September 24, 1981
L-81-420

Re: St. Lucie Unit 2
Docket No. 50-389
Final Safety Analysis Report
Requests For Additional Information

Attachment to L-81-420
September 24, 1981

FIGURE 2 SHIELD BUILDING EXHAUST FAN

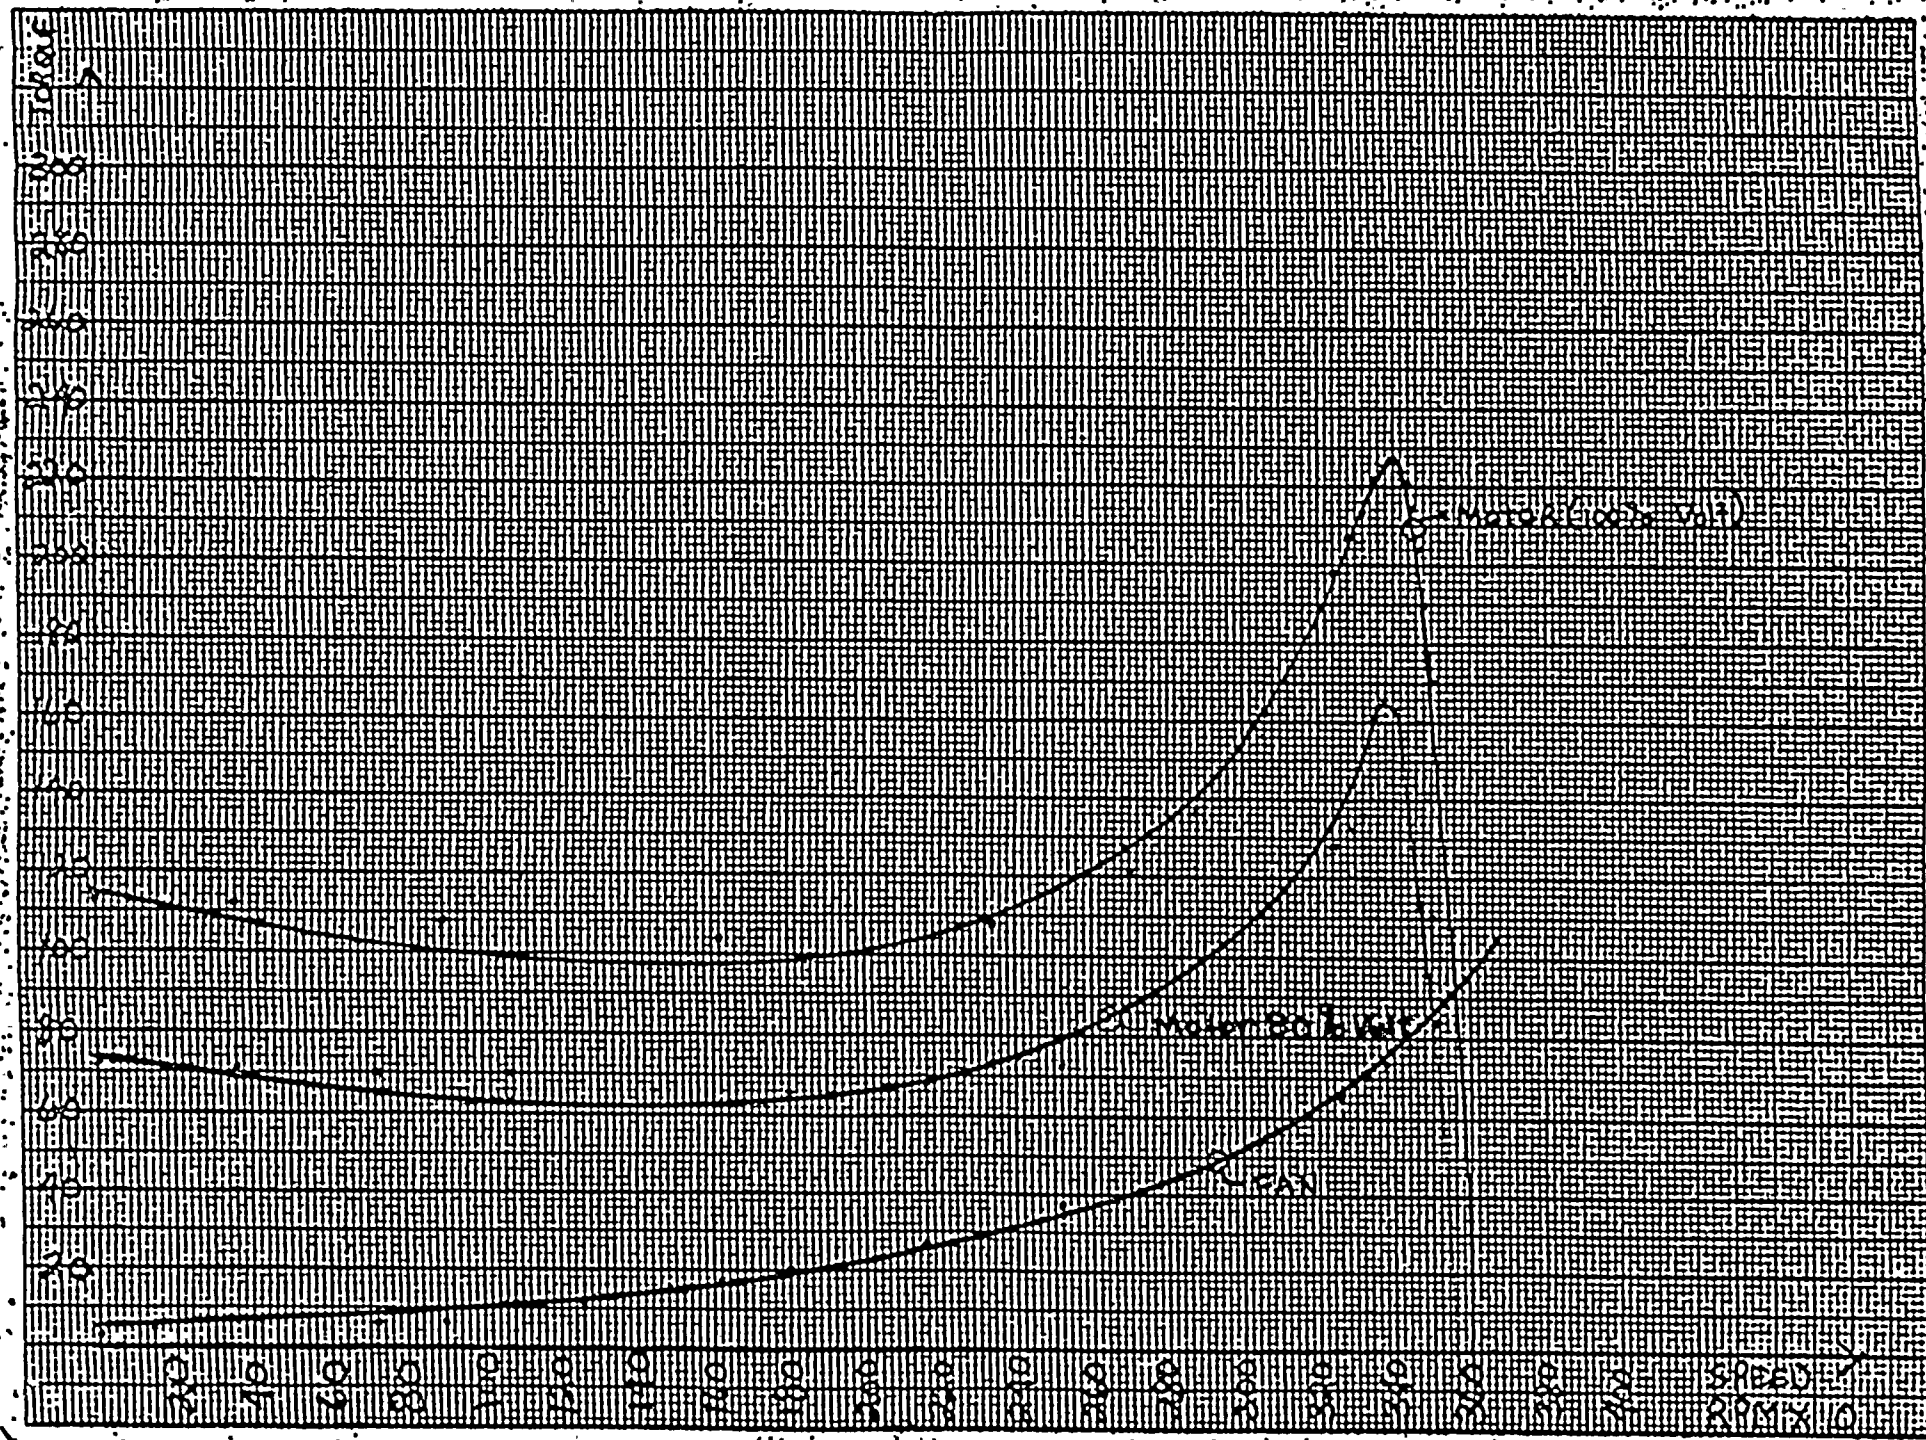
in a similar manner as the containment fan coolers described above utilizing the same conservative constant 80% motor terminal voltage. The speed torque curve, taken from manufacturers data for the motor and load is shown on Figure 2. The acceleration time is calculated for this motor is 4.9 seconds. Again comparing this time to the time assumed in the accident analysis, 10 seconds, and comparing this time to the safe stall time typical for motors this size, 11 seconds, indicate that the reduced voltage starting of this motor and load does not impact the safety analysis or damage the motor.

Figure - 1

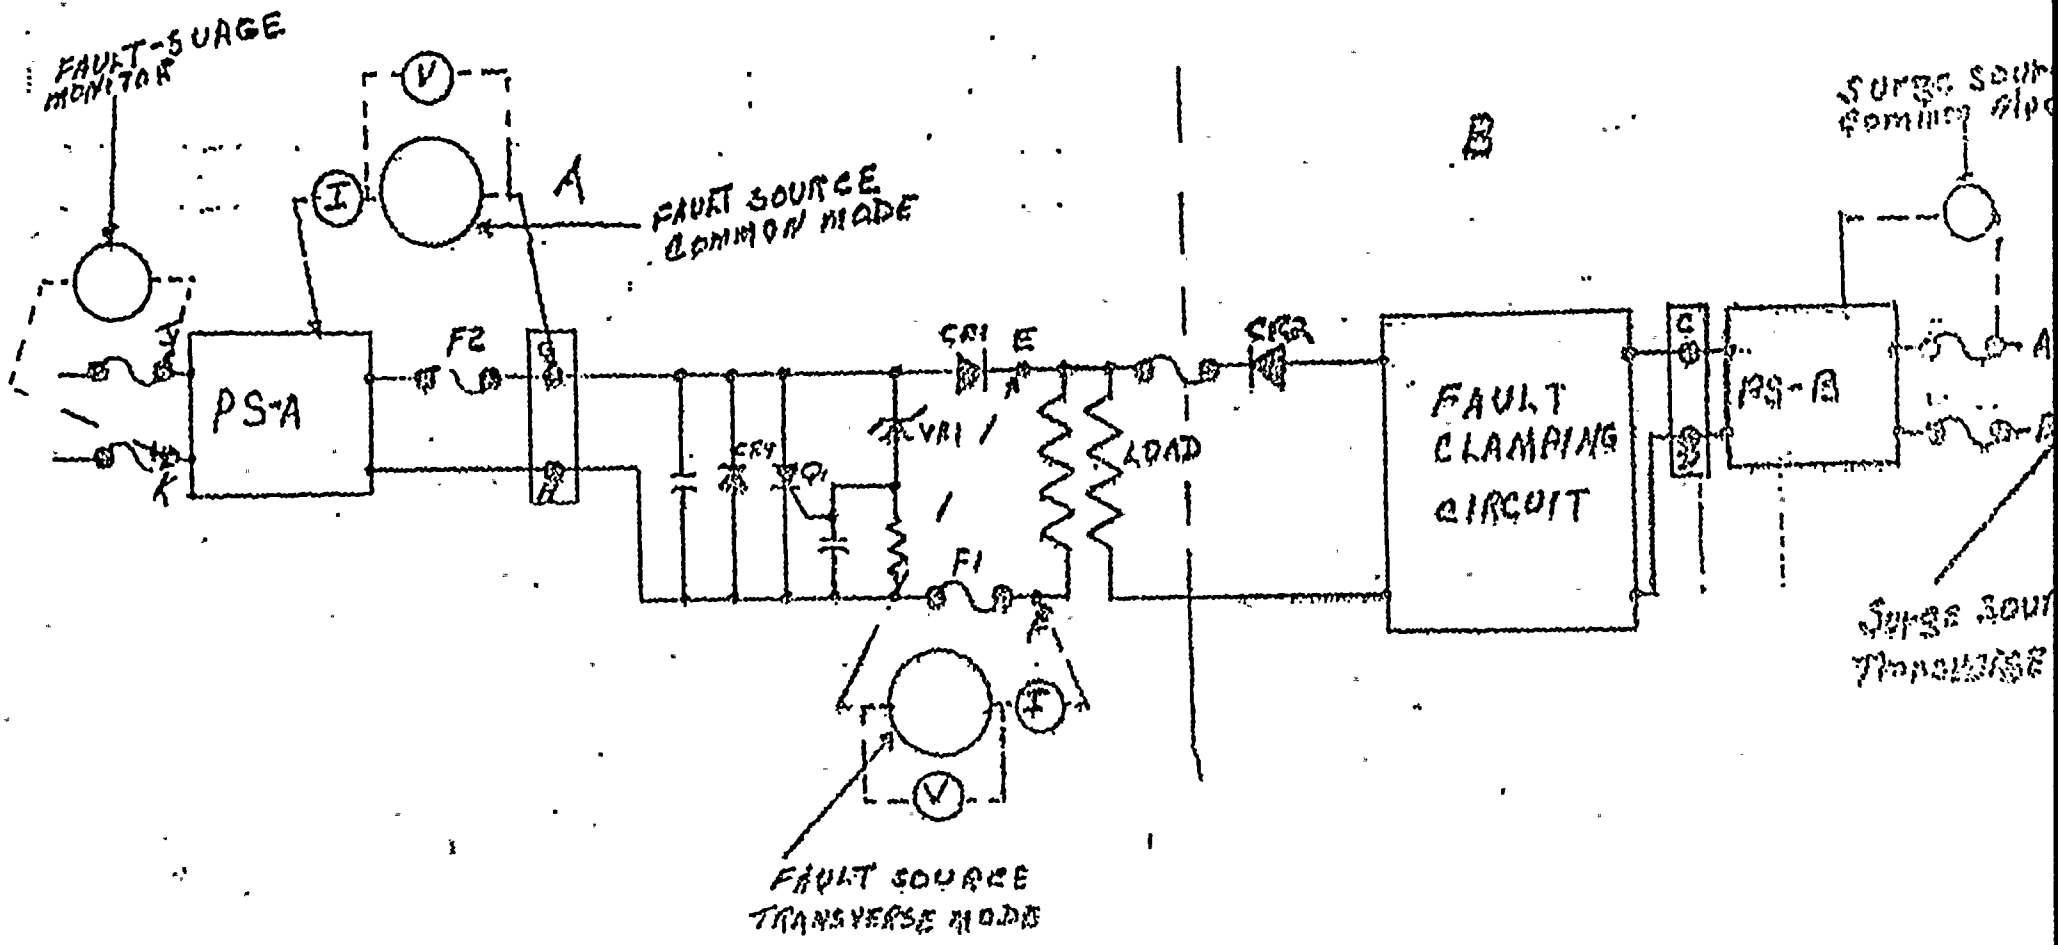
Matrix power supplies and isolation circuits are configured within the RPS as shown in Figure 1. The isolation test will consist of the application of a 600 Vac and 400 Vdc fault in the circuit in the common and transverse modes. The basis for the 600 Vac and the 400 Vdc test voltage is as follows:

For the purpose of this test, it has been conservatively assumed that it is a fault appeared on vital bus B (points A or B to chassis ground in Figure 1) it

would propagate through the DC power supply (PS-B) and appear at points C or D. Since PS-B is directly connected to PS-A (through CR-1 and CR-2) the fault is assumed to appear at points G of H to ground. Therefore, it is required to show that when a fault is present on the BC side of a matrix power supply it does not propagate to the 120 Vac side of the power supply, thereby affecting more than one vital bus. It should be noted that complete propagation of a fault from power supply primary to secondary is a conservative fault circuit evaluation which would most likely not occur.

Similar to the common mode test, a fault appearing on vital bus B (Figure 1 points A and B) is assumed to propagate completely to points E and F. Therefore, it must be shown that application of a fault to the output of the isolation circuit (points E and F) does not propagate in the 120 Vac side of power supply A thereby affecting more than one vital bus. It should be noted that the isolation circuit clamps the fault voltage such that power supply damage does not occur, as discussed below:

Clamp Circuit - The power supply fault clamp circuit is designed to limit or shortout a positive or negative fault. Figure 1 is a schematic of the fault clamp circuit which is connected to each matrix power supply. During normal operation VRI is in the open circuit condition, SCR-Q1 is deenergized and CR4 is reverse biased. The normal 28 Vdc output of the power supply will be seen between points E and F.

1. Common Mode Test (Figure 1)

The common mode test is accomplished by applying a surge to the AC side of the matrix power supply between point (A) and the power supply chassis. During surge application the simulated RPS circuit is operated to show proper function and accuracy. Also, the 120 Vac line of the associated power supply is monitored across points (J) and (K). The same process is repeated for point (B) and the power supply chassis.

2. Transverse Mode Test (Figure 1)

The transverse mode test is accomplished by applying a surge to the AC side of the matrix power supply between points (A) and (B). During application of the surge the simulated RPS circuit is operated to show proper function and accuracy. Also the 120 Vac line of the associated power supply is monitored across points (J) and (K).

Figure -2

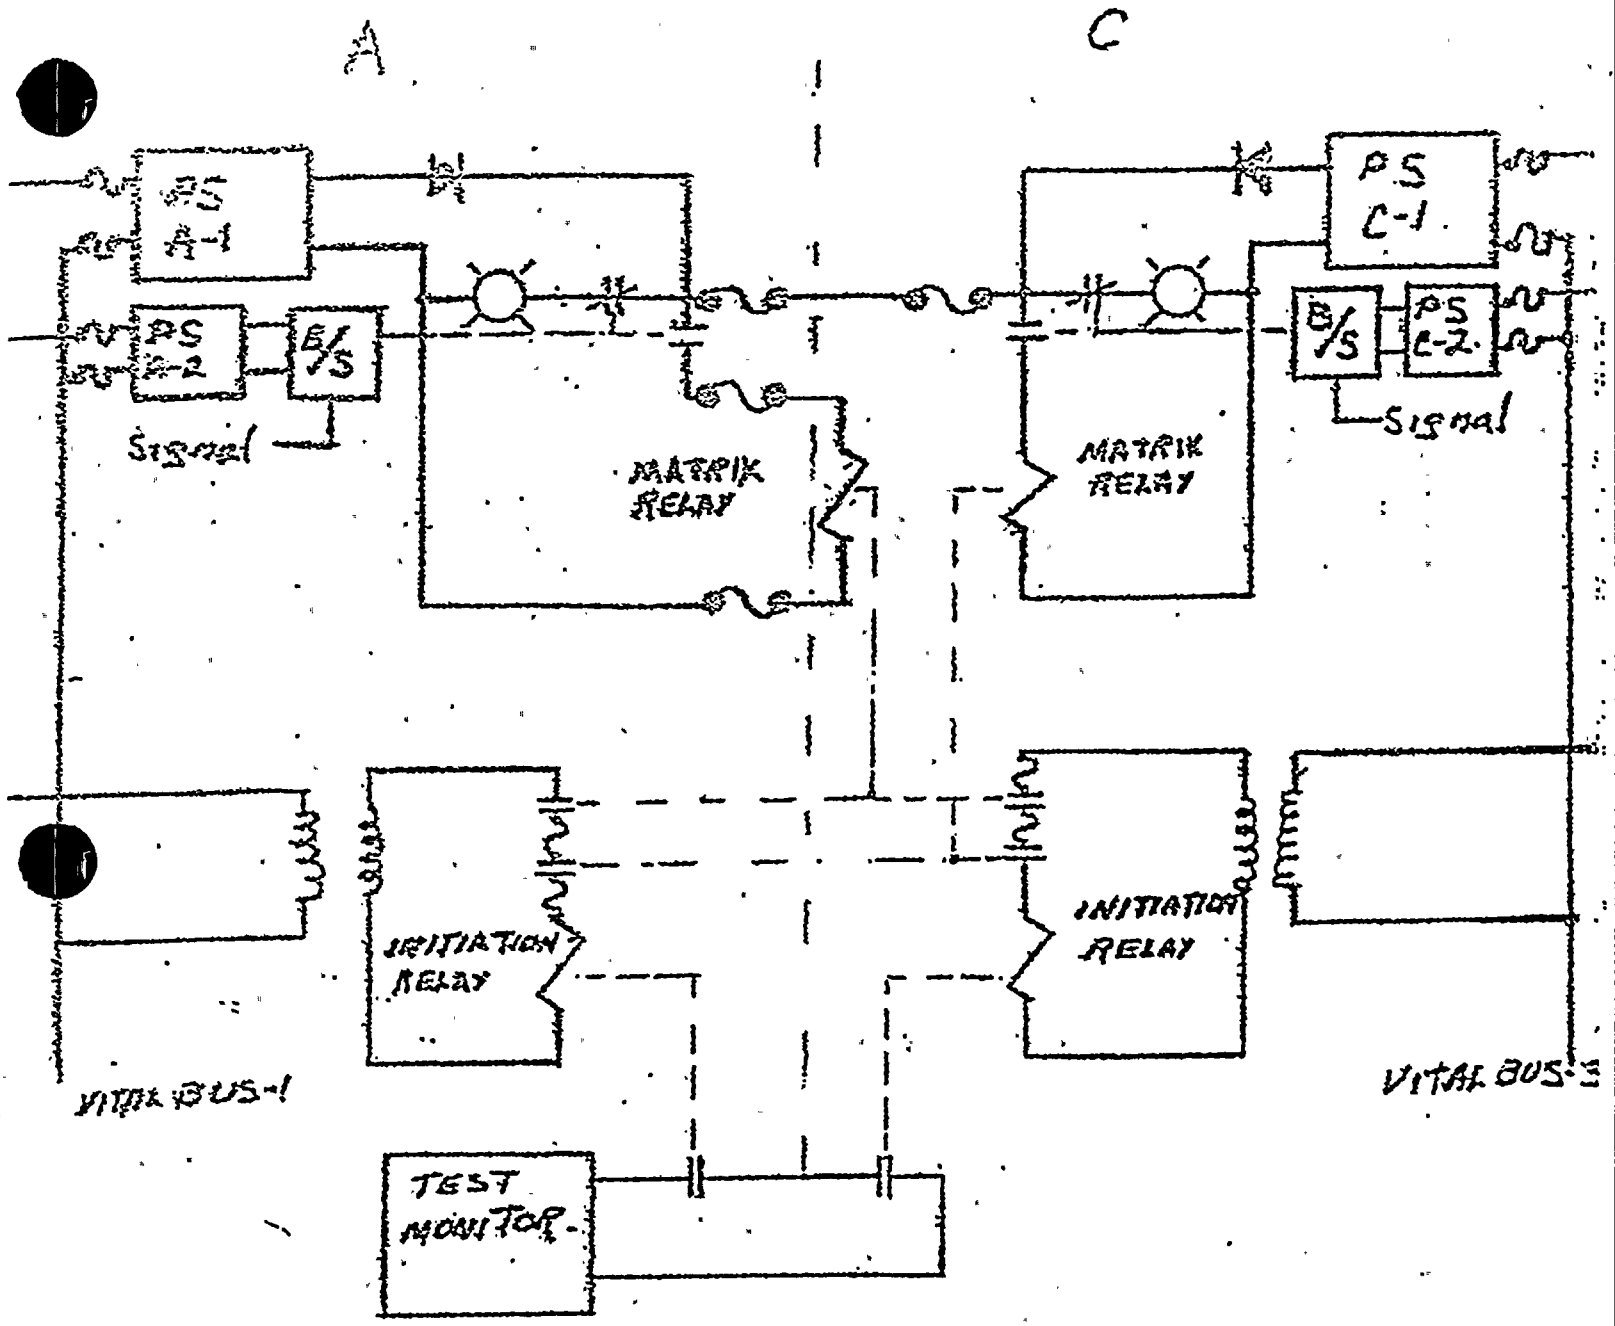
The test involves simulating (with identical equipment) a typical RPS matrix (Figure 2) including bistable trip units, bistable power supplies, matrix power supplies, matrix relays, and isolation relays. Vital bus power (120 Vac) is simulated by using two power isolation transformers. A 300 Vac surge (negative peak to positive peak) will then be superimposed on one vital bus. Thus, the test voltage from neutral to peak will be 337 volts (120 Vac + 10%) x 1.414 plus the neutral to peak surge 300V/2. The surge voltage is based on a calculation performed for the ANO-2 PPS which concluded that circuit damage or false operation would not occur provided the peak AC voltage is maintained below 400 Vac. Since the equipment within the St. Lucie Unit 2 PPS is similar (but not identical) to the ANO-2 PPS it is assumed that calculation conclusions are applicable to the RPS.
